World Forum for Harmonization of Vehicle Regulations

Working Party on Passive Safety

Report of the Working Party on Passive Safety on its sixty-third session

Figure 1, correct to read:

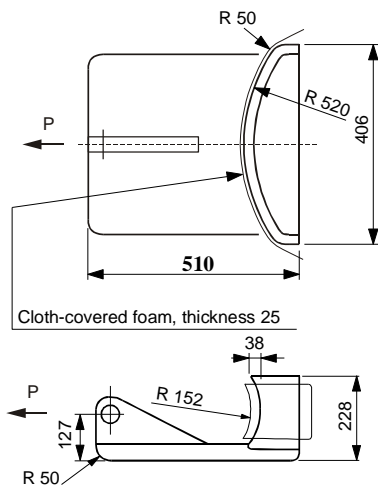
15. GRSP noted ECE/TRANS/WP.29/GRSP/2018/12, which corrects the dimensions of Figures 1 and 1a of Annex 5. GRSP adopted ECE/TRANS/WP.29/GRSP/2018/12 as reproduced in Annex IV to this report. The secretariat was requested to submit the proposal as draft Corrigendum 2 to Revision 5 to UN Regulation No. 14, for consideration and vote at the November 2018 sessions of WP.29 and AC.1.

Annex 5,
